BOSTON REGION METROPOLITAN PLANNING ORGANIZATION

DATE April 3, 2014
TO Boston Region Metropolitan Planning Organization (MPO)
FROM William Kuttner, MPO Staff
RE A Preferential Lane on I-93 North: A Conceptual Plan

Comment Letter from I-93/I-95 Interchange Consulting Engineers

Date: March 5, 2014
To: Ed Hollingshead
From: Rick Azzalina
Re: A Preferential Lane on I-93 North: A Conceptual Plan
FST Review Comments

FIGURE 2
Proposed Sections of I-93 North
Preferential Lane System

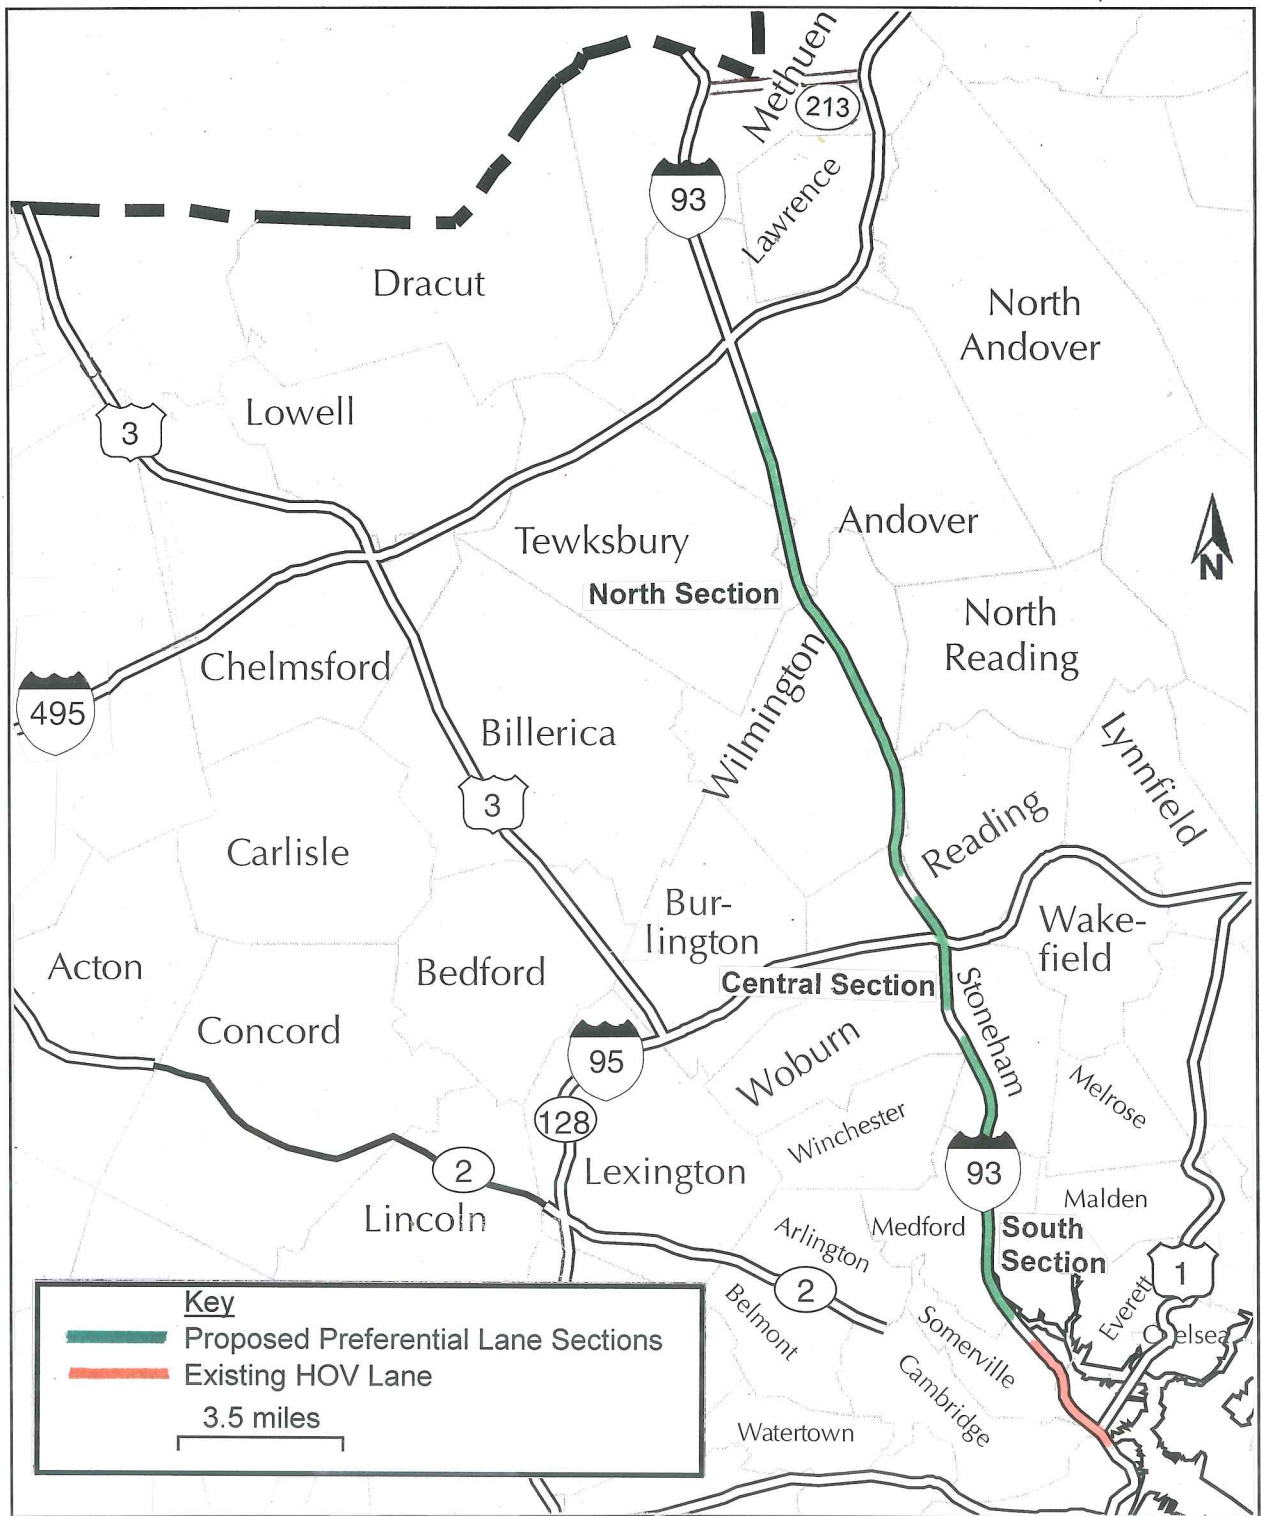
1. On Page 3 a statement reads *“The Phase II Study focuses on I-93 north of Boston, and proposes a system that would function as an extension of the existing north-side HOV facility, as shown in Figure 2.”* This terminology is confusing. The existing HOV facility is a southbound HOV facility from approximately the Medford/Somerville line to the Charles River Crossing. *[This text has been modified.]*
2. The Introduction and Background sections of the memorandum provide the reader with a brief but comprehensive history of the HOV lane, and its various extensions, north of Boston. This historical information is quite helpful and provides a basis for the current recommendations.

FIGURE 3
Southbound: Existing and Proposed Lanes, Ramps, and Reversible Preferential Lane

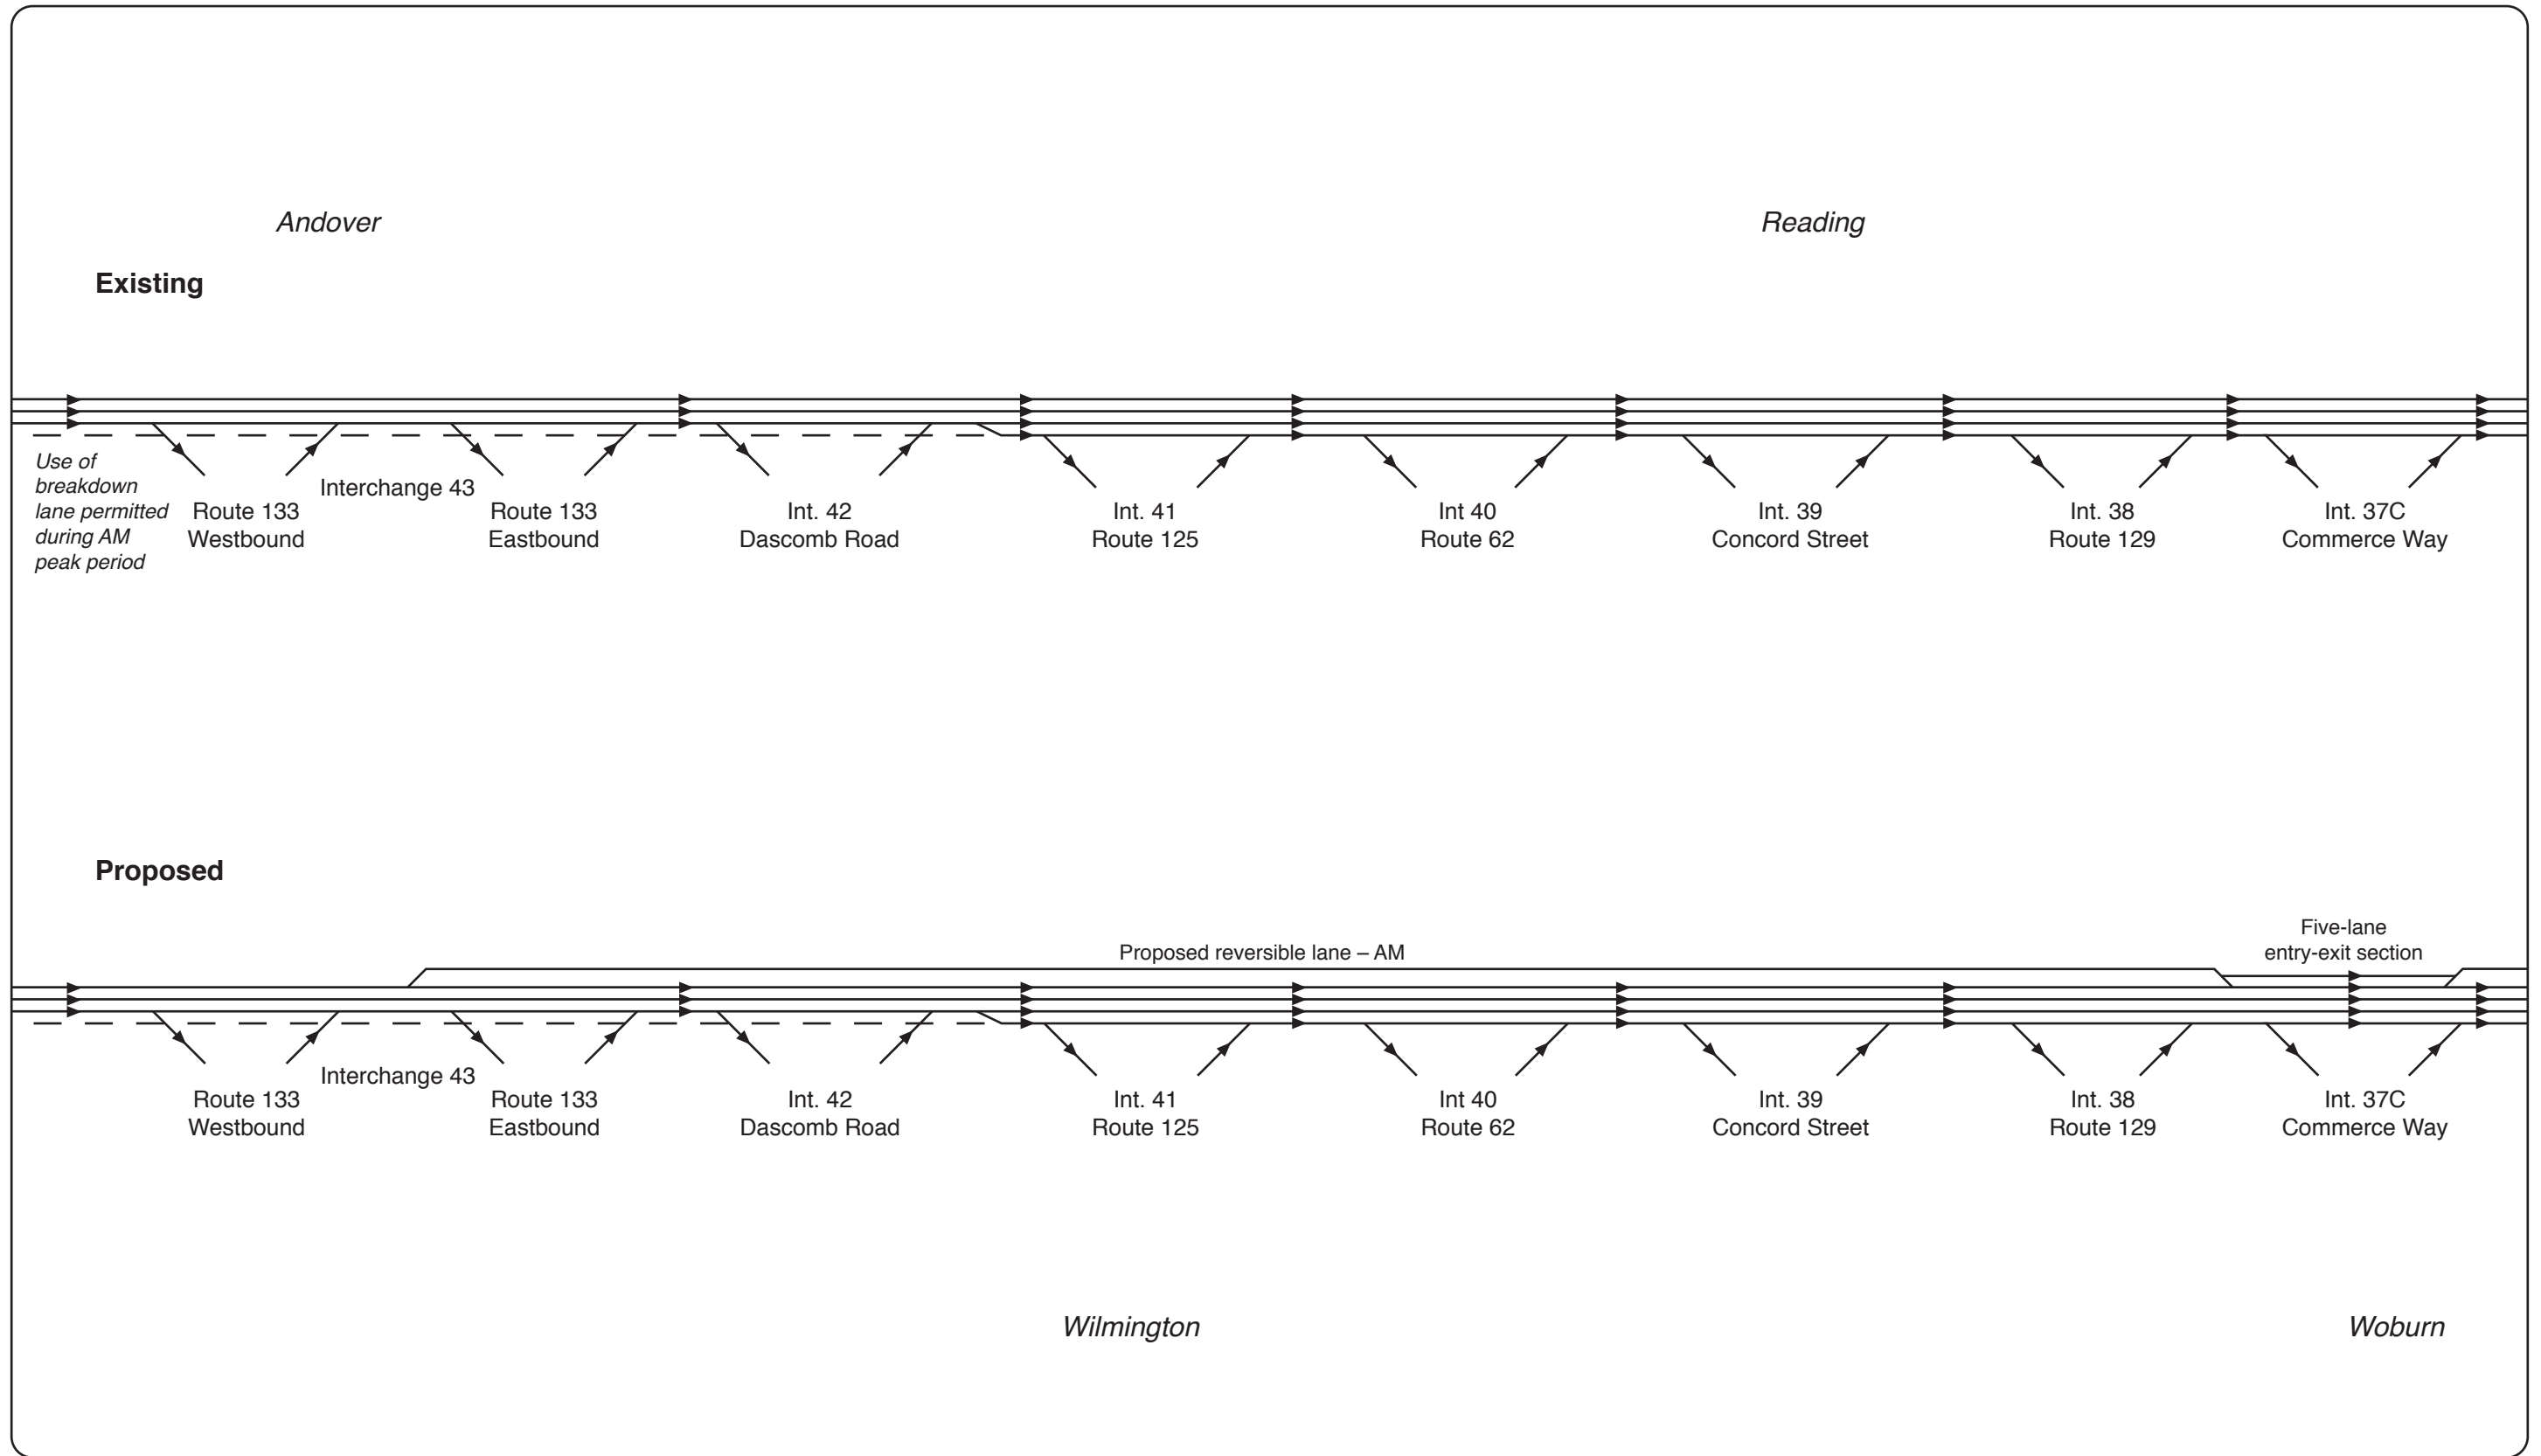
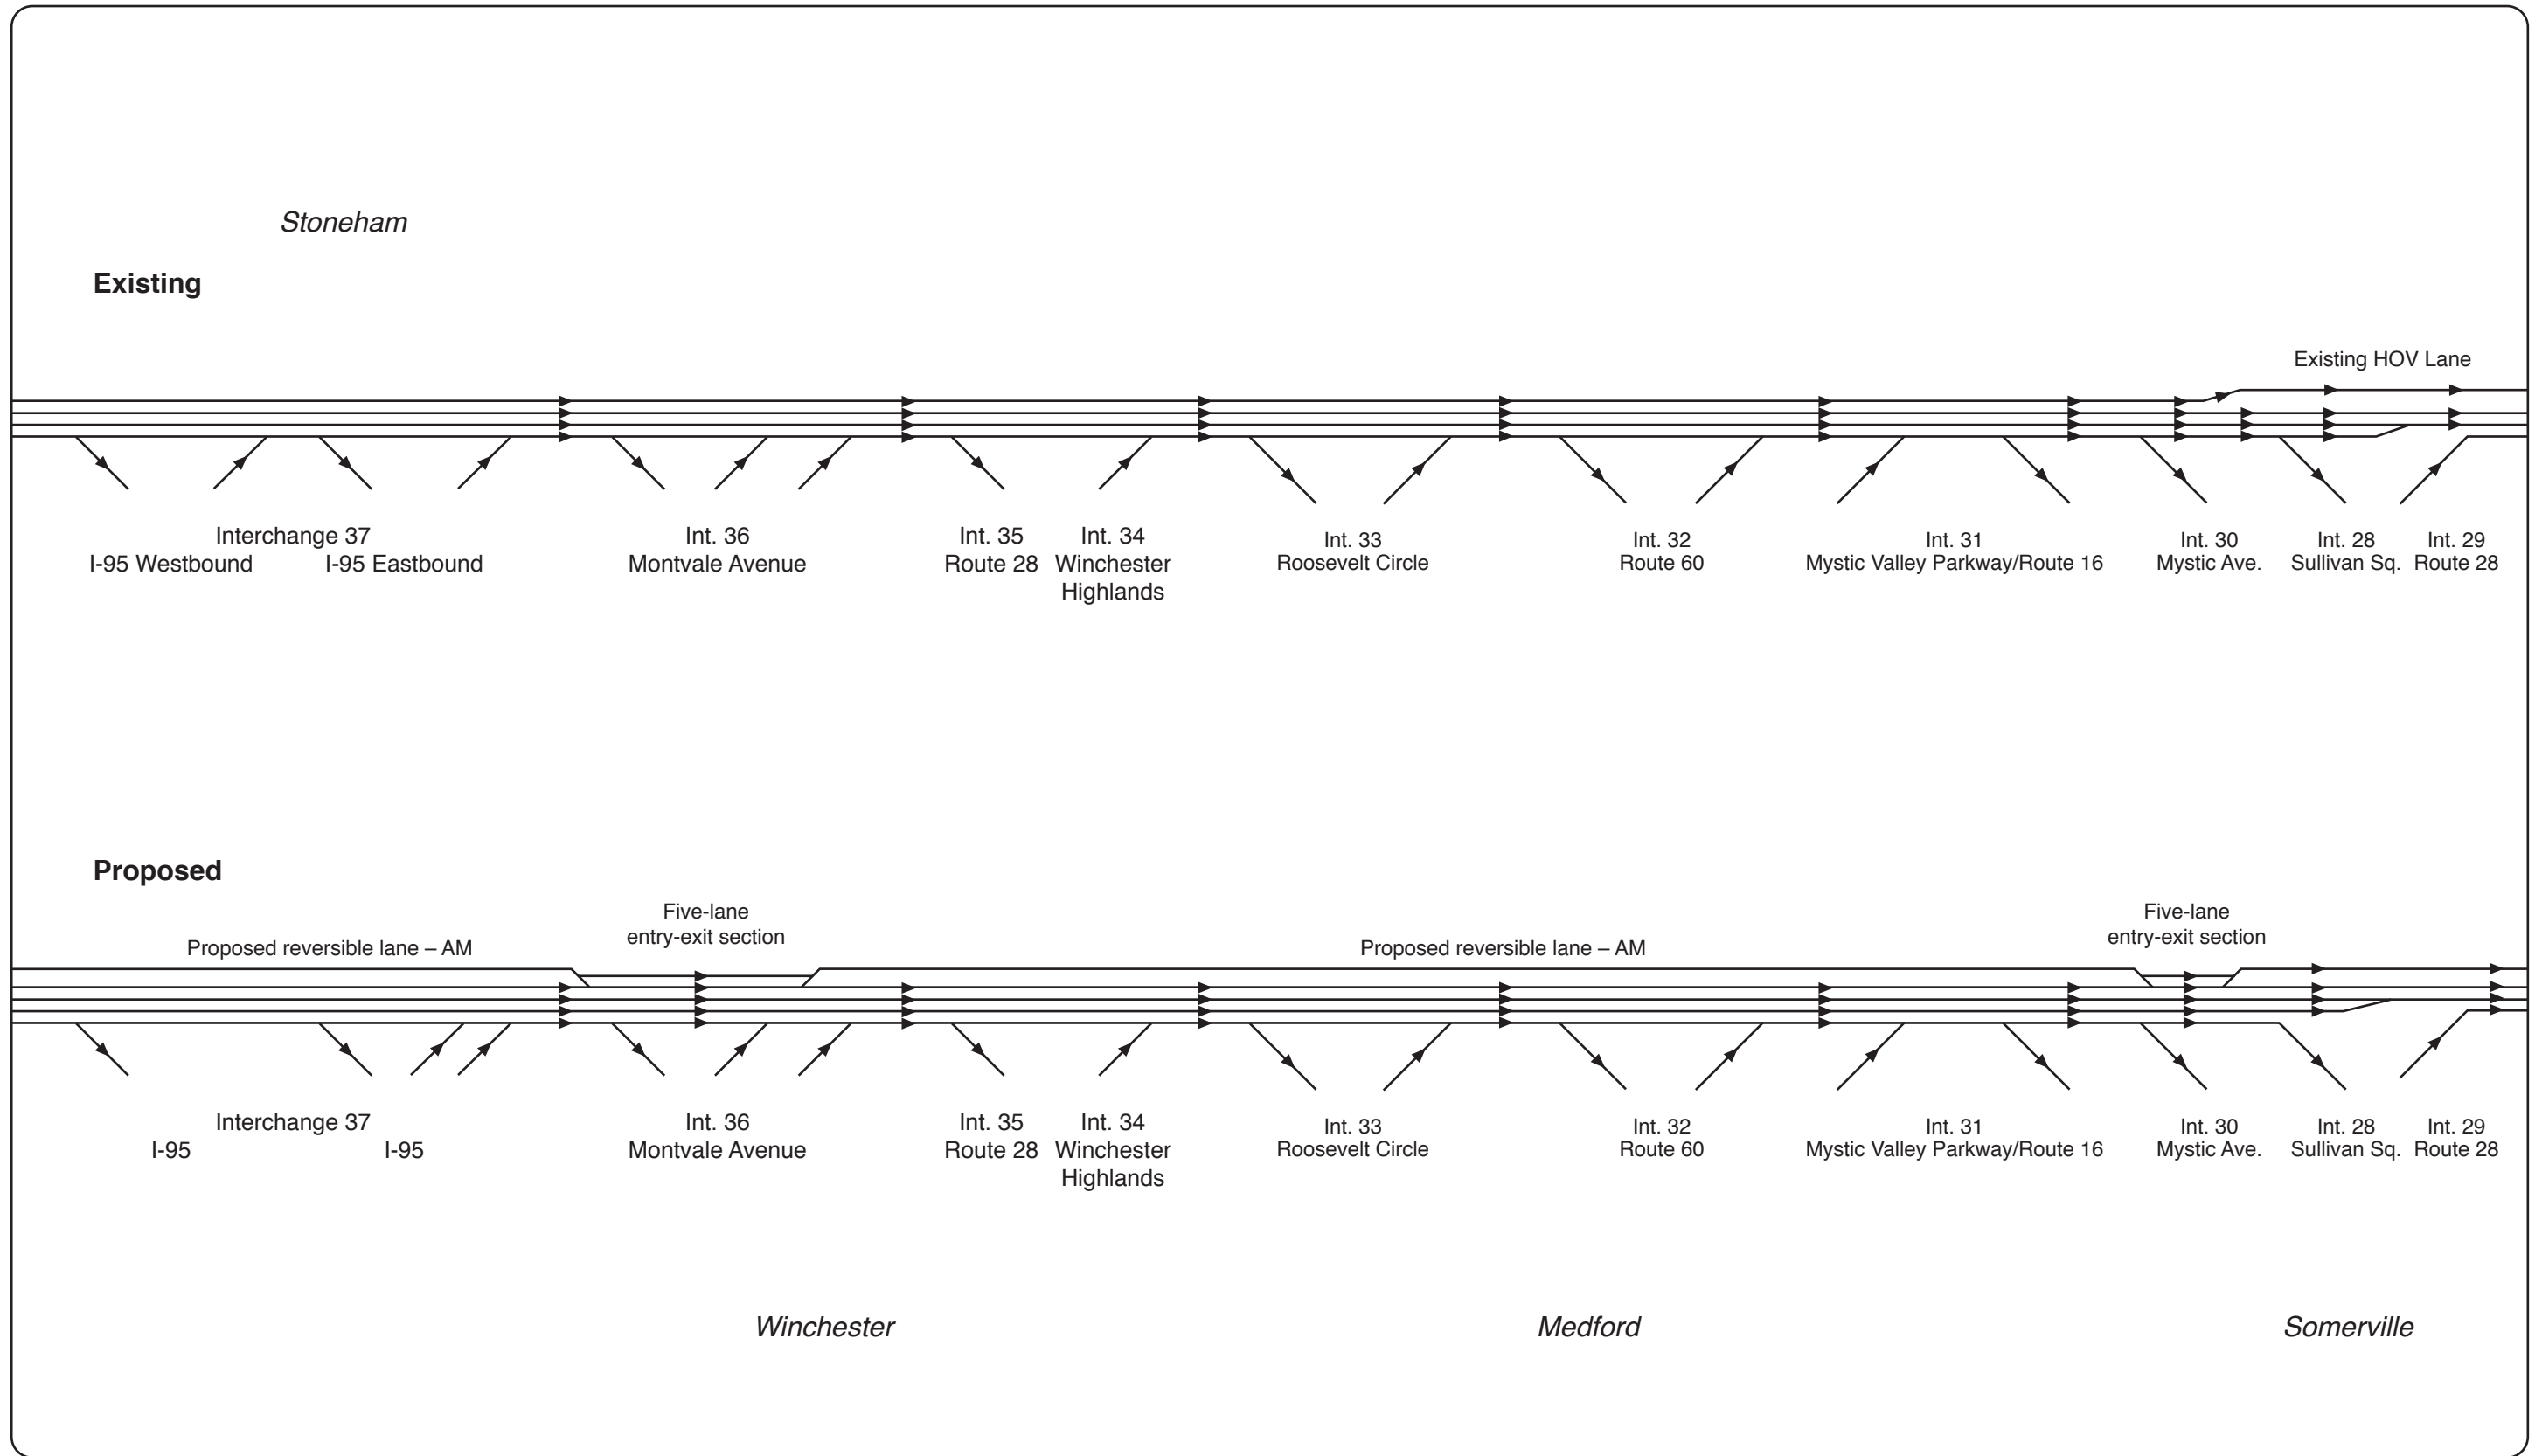
9. On Page 12, regarding the proposed northern terminus of the southbound preferential lane system is states "*The entrance of the reversible lane is shown in Figure 3 as positioned among the cloverleaf ramps of Interchange 43. The entrance would be south of the Route 133 viaduct that crosses I-93, thereby eliminating any need to reconstruct this viaduct.*" Based on Figure 3 and the above language, it appears the entry point is located between the I-93 southbound on ramp from Route 133 and the I-93 southbound off ramp to Route 133 East. An entry at this location would be problematic because of the proximity of the Route 133 clover leaf on ramp to I-93 southbound and the potential for undesirable weaving patterns. For I-93 southbound traffic an approximate taper distance of 1000 feet is required to achieve the necessary 26 foot shift and enter the preferential lane in the median. For these reasons, it is recommended the entry point (i.e., start of physical barrier separation) be shifted further north just north of the I-93 southbound on ramp from Route 133 and as far south as possible from I-495.

12. The five-lane entry-exit section at Interchange 36 (Montvale Avenue) appears to be located where problematic weaves could result. The limits this reversible, entry-exit section appears to be different on Figure 3 from that shown on Figure 4. We suggest moving this 1,500 section further north such that the physical separation between the preferential lane and general purpose traffic ends just north of the I-93 southbound on ramp from Montvale Avenue westbound. The terminals for the existing I-93 southbound off ramp to Montvale Avenue and the existing I-93 northbound on ramp from Montvale Avenue should be extended northerly to physically prohibit traffic connections between the reversible, preferential lane and Interchange 36. Modification of these ramp terminals should not be a problem since these ramps are connected to extended auxiliary lanes.

FIGURE 7
Narrow Corridor
Entry-Exit Section

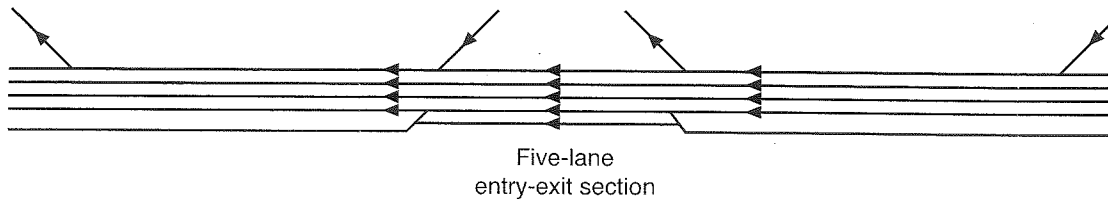
18. On Page 39 it states *“Design guidelines recommend that the parallel general-purpose and preferential lanes allow a distance of between 1,000 and 1,500 feet in which vehicles can enter or exit the preferential lane system.”* Due to the significant traffic volumes along the I-93 corridor in both the AM and PM peak periods we would suggest using 1,500 feet as the design length of entry-exit sections and, to minimize right of way impacts, applying this length to the configuration shown on Figure 7 on Page 40 where weaving takes place in the adjacent general purpose lane.
